# Root Cause Analysis (Tube Bundle)

# Tube Bundles Progress Report

## Revised Method of Packing

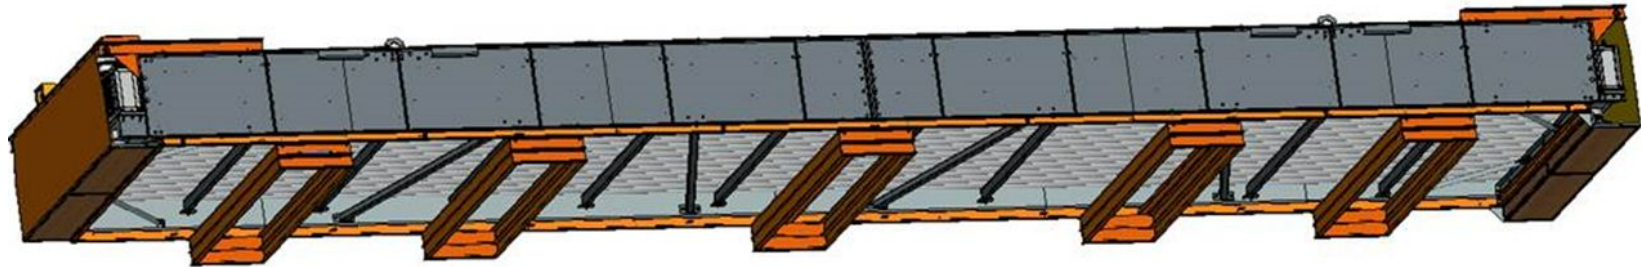
BHM made variations in tube bundle packing, only top protection provided. As well, BHM removed plywood sheets from the bottom of frame.

# Tube Bundle Frame Design

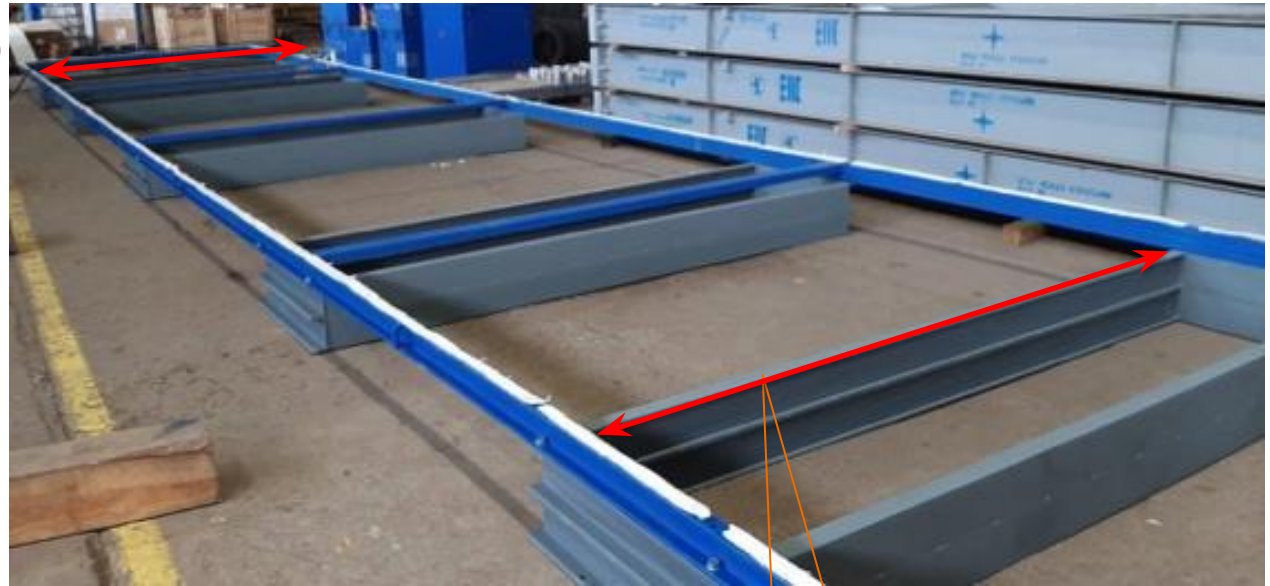
**Flaws:**

- Missing transversal beams No. 1 and 5 in frame over the support beams and in the lashing points to distribute the weight.
- No 100% overlap: C-Chanel frame shorter than C-Chanel of support

No transversal beams over supports to distribute the weight

1. Suspension of loading & dispatch operations of tube bundles until BHM will re-visit structural analysis (calculations) Reinforcement of the supports and additional structural analysis
  - a. Reinforcement plates welding (see below)
  - b. Reinforcement backbone welding (see below)
  - c. Additional Transversal beams in transport frame

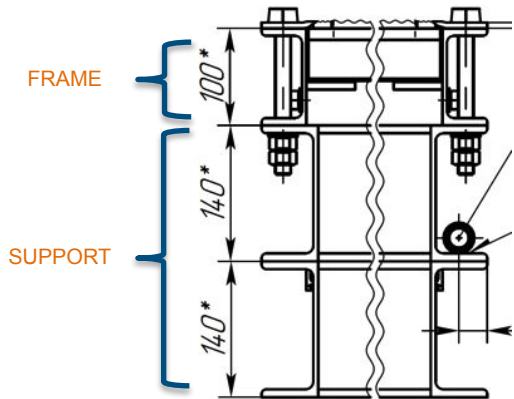
No 100% overlap: C-Chanel frame shorter than C-Chanel of support

Visual Inspection of tube bundle # 102 on rail platforms

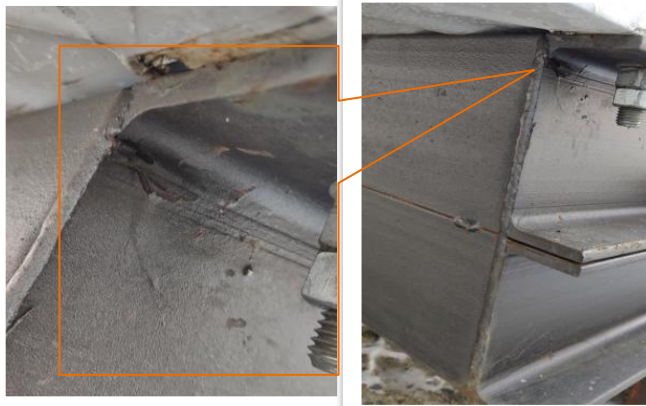
- Visual inspection of 2 other tube bundles #95 and #101 were conducted;
- Tube bundles #94 and #102 supports were closely inspected on the wagons (arrival on 11.12.2020) in order to eliminate possibility of mishandling in Nogliki

Visual inspection results: 3 of 4 tube bundles have cracks in the support #1 and C-Chanel bends in other supports

Kerry have visually inspected part of the support beam and found cracks in the transport frame beams (as shown in the pictures).
